Norwich to Tilbury

Document: 9.12 Proposed Change Application 2: Addendum to
Environmental Statement - Change Request 2 (Little Bromley) (CA2)

Final Issue CA2

March 2026

Title:
**Figure CR2.1 - Environmental Constraints -
Change Request 2: Little Bromley**

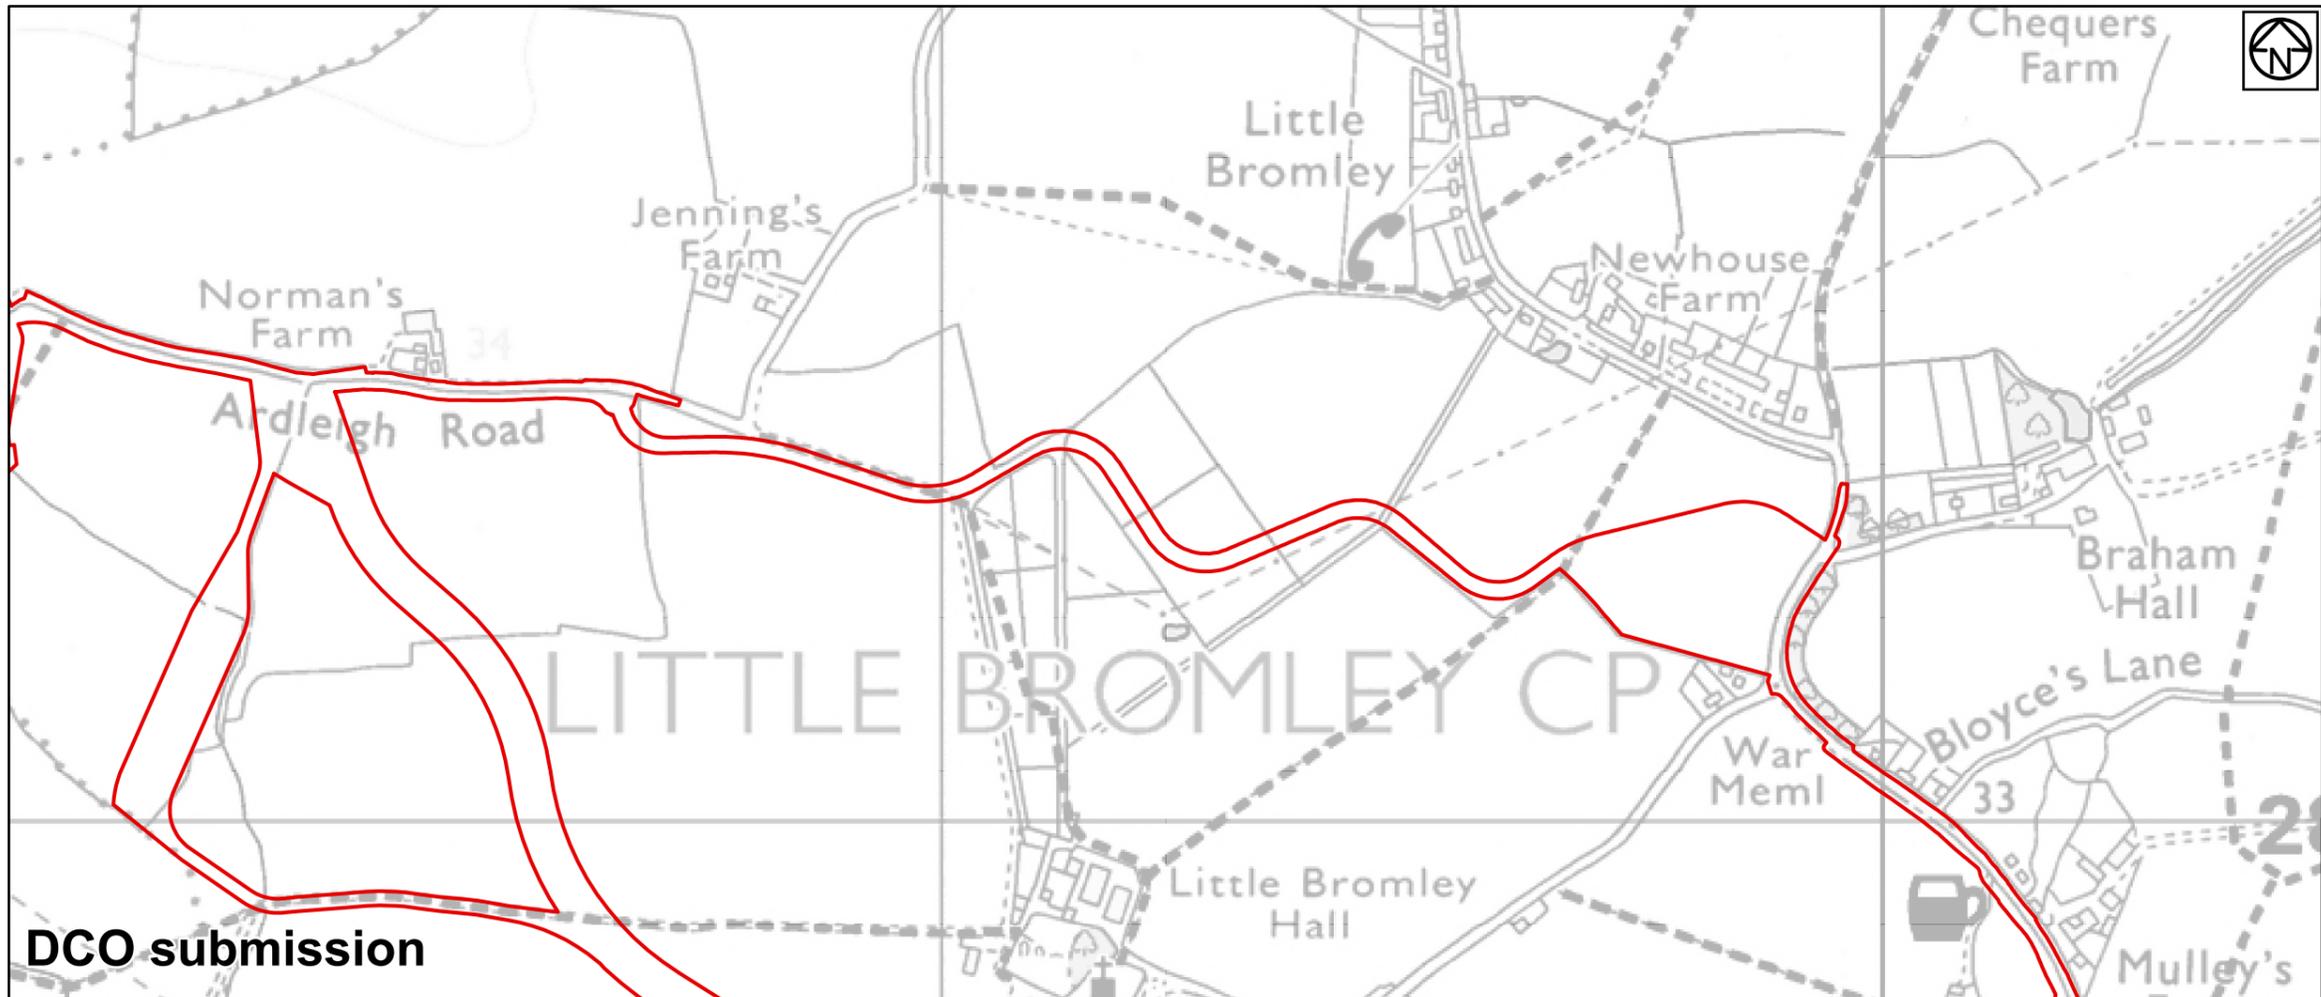
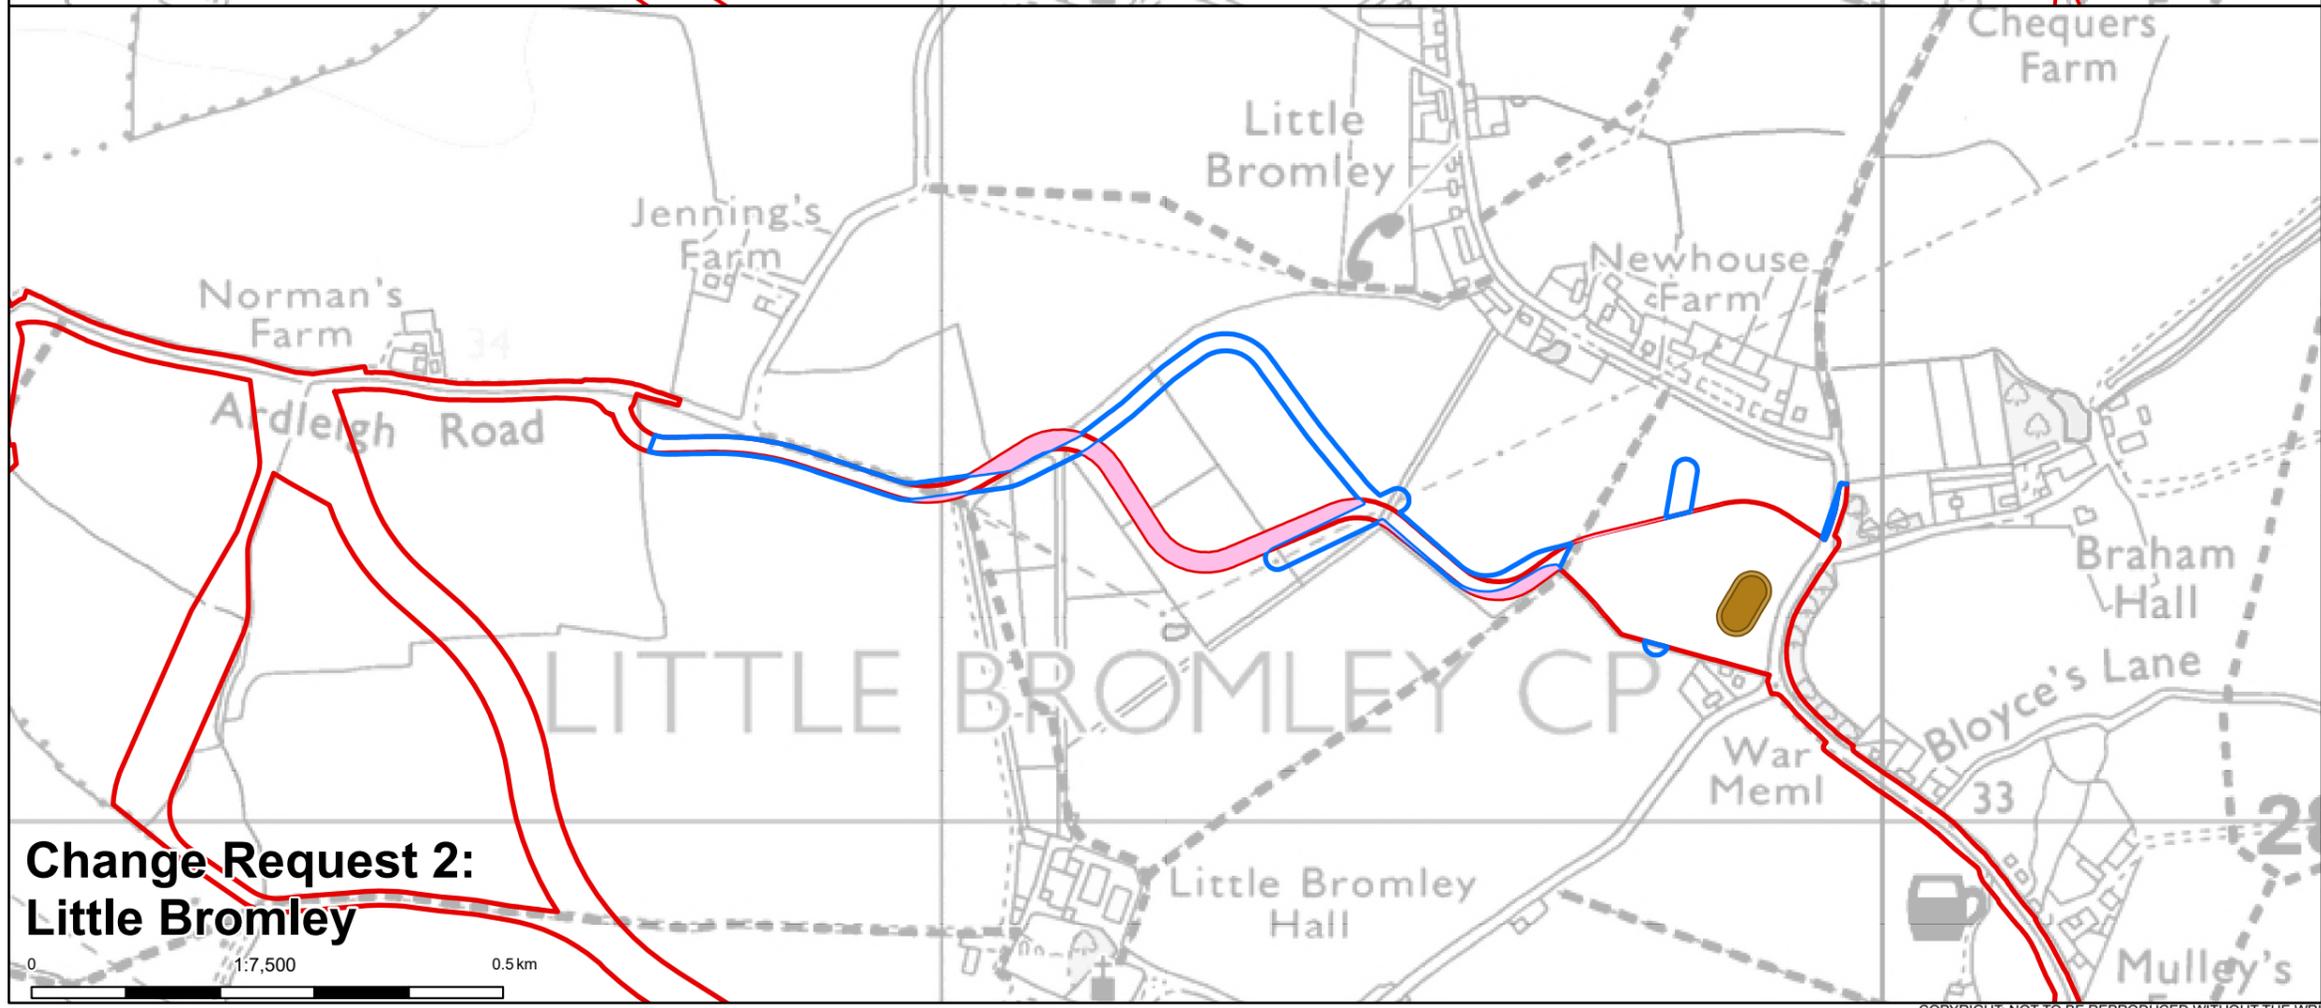
- 1.3.1 The Project's proposed access arrangement to the proposed EACN Substation ('Proposed Route') would use a route passing to the south of Little Bromley, Essex (see Figures CR2.1, CR2.2 and CR2.3 in Appendix A).

- 1.3.3 The proposed design change would involve two modifications to the Proposed Route:
- First, a section of the Proposed Route nearest to Bentley Road is realigned to the south, for the permanent access relating to Abnormal Indivisible Loads (AILs) during the operational phase of the Project. The need for a permanent AIL route is to ensure supply standards for the connection are met in the future (by allowing replacement of any component at short notice).

- Second, to the northwest of the first modification, the Proposed Route for both construction and operational vehicles is changed to generally follow the alignment of the Proposed Route presented at statutory consultation between 10 April and 26 July 2024.

Title: Figure CR2.7 - Other Environmental Constraints (Change Request 2)

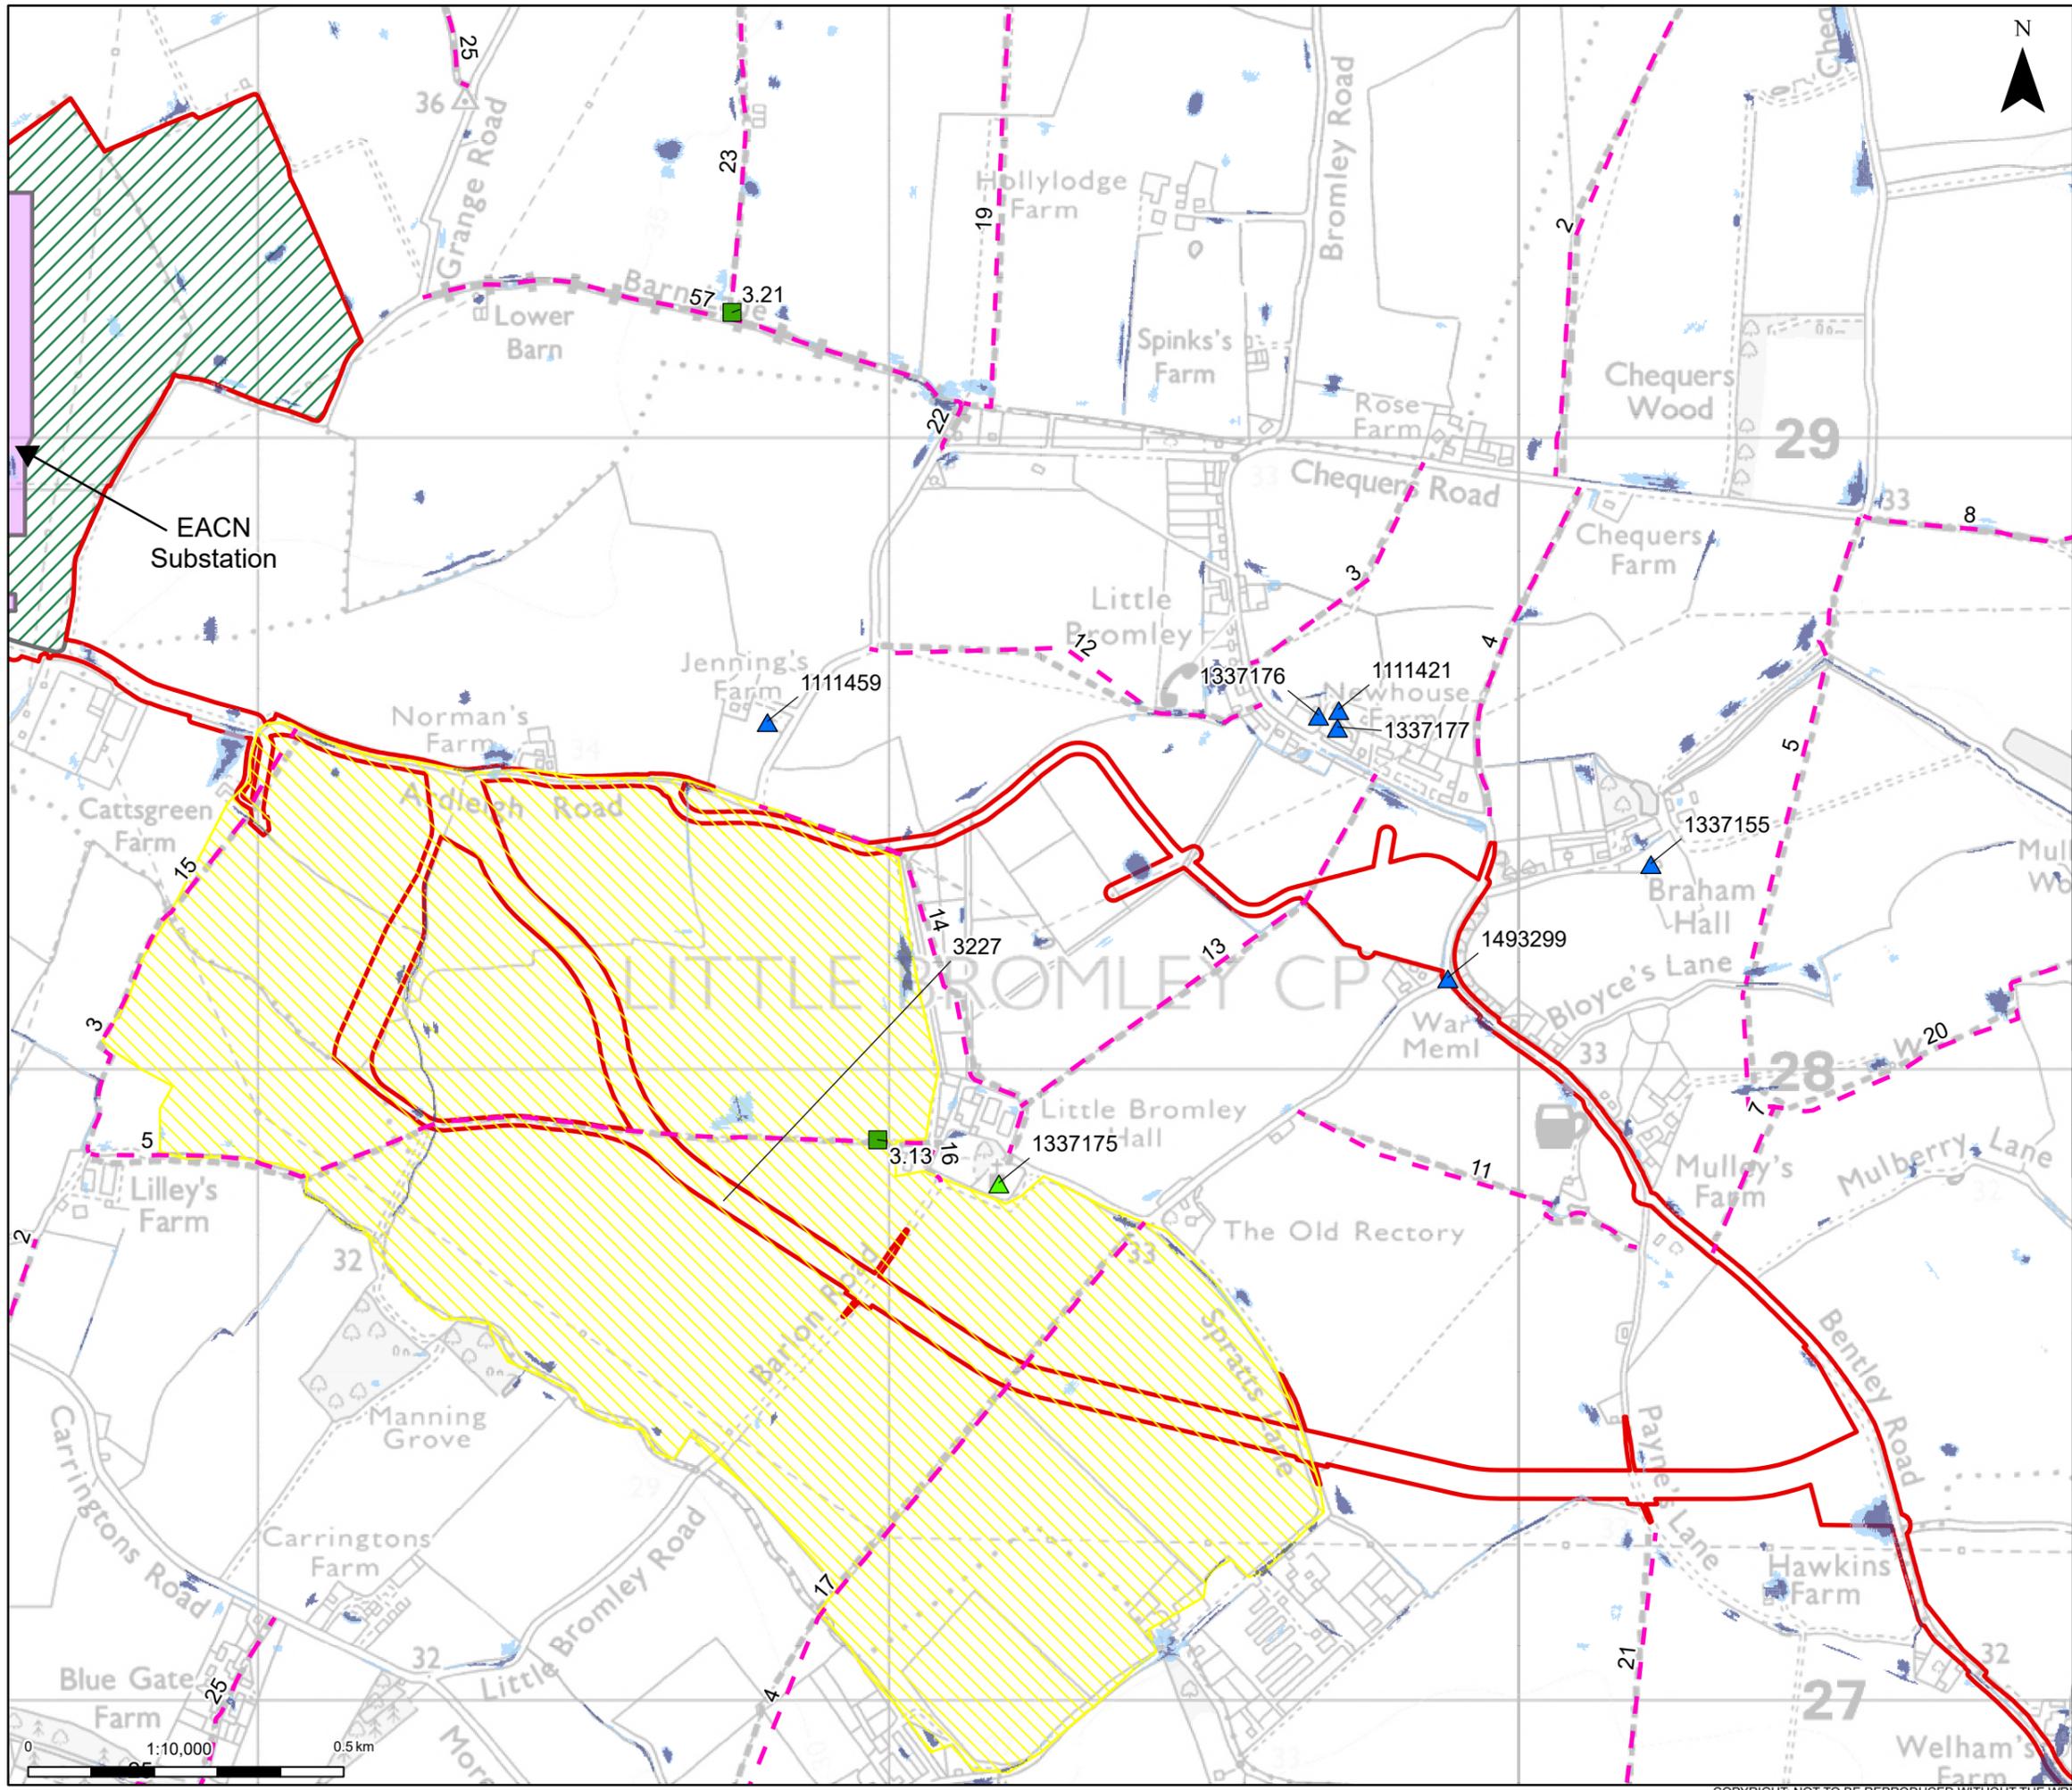
APP-271	6.16 Environmental Statement Chapter 16 - Traffic and Transport	<p>The proposed design change would impact the PRoWs Little Bromley 13 and Little Bromley 14 (see Figure CR2.7 in Appendix A), which are already impacted by the Project. Therefore, the proposed design change would not result in any changes to the outcome of 6.16 Environmental Statement Chapter 16 - Traffic and Transport [APP-271], following the implementation measures set out in 7.6 Outline PRoW Management Plan [APP-329].</p> <p>In terms of construction traffic, the peak activity on associated Primary Access Routes (PARs) would not increase and the findings of the assessment in 6.16 Environmental Statement Chapter 16 - Traffic and Transport [APP-271] would remain not significant.</p> <p>As set out in 6.19 Scoping Report [APP-296] and 6.20 Scoping Opinion [APP-297], the operation (and maintenance) phase of the Project would not result in any significant effects to traffic and transport. The proposed design change would not alter the scope in 6.19 Scoping Report [APP-296] and 6.20 Scoping Opinion [APP-297], and therefore, has not been considered further.</p>

1.4.37 APP-333	1.4.38 7.11 Transport Assessment	<p>1.4.39 The proposed design change would impact the PRoWs Little Bromley 13 and Little Bromley 14 (see Figure CR2.7 in Appendix A), which are already impacted by the Project. Therefore, the proposed design change would not result in any changes to the outcome of 7.11 Transport Assessment [APP-333].</p> <p>1.4.40 In terms of construction traffic, the peak activity on associated Primary Access Routes (PARs) would not increase and the findings of the assessment in 7.11 Transport Assessment [APP-333] would not change.</p>

1.4.28 APP-329	1.4.29 7.6 Outline PRoW Management Plan	1.4.30 This document will be updated to capture the change in construction activity interaction with the PRoW that cross the haul road.
